Service Bulletin

Bulletin No. 2011-62
CMD 2011-02

VesselView Displays Damaged by Voltage Spikes

Installing the Resistor

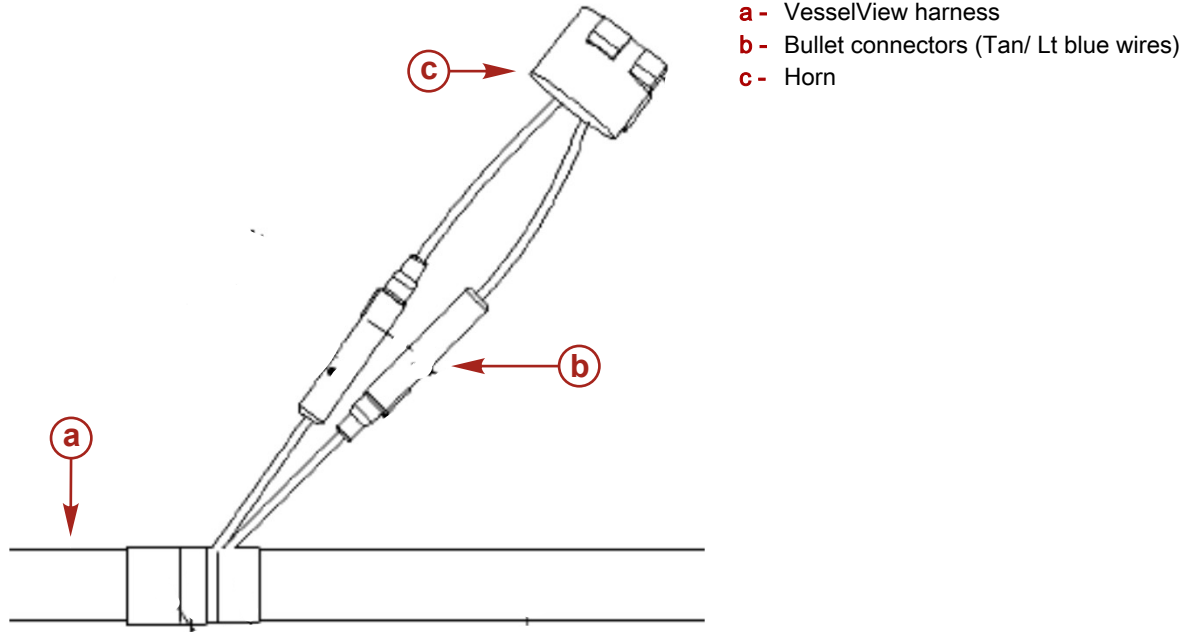
A voltage spike in the horn circuit could damage the VesselView display and result in a continuous sounding horn.

Install the wire with the resistor for the horn between the Tan/ Lt blue wire bullet connectors on the VesselView harness.

1. Separate the male and female bullet connectors on the Tan/ Lt blue wire between the horn and the VesselView harness.

2. Connect the resistor wire bullet connectors (male and female) to the corresponding bullet connectors on the Tan/ Lt blue wires.
3. Secure resistor and wire as necessary.
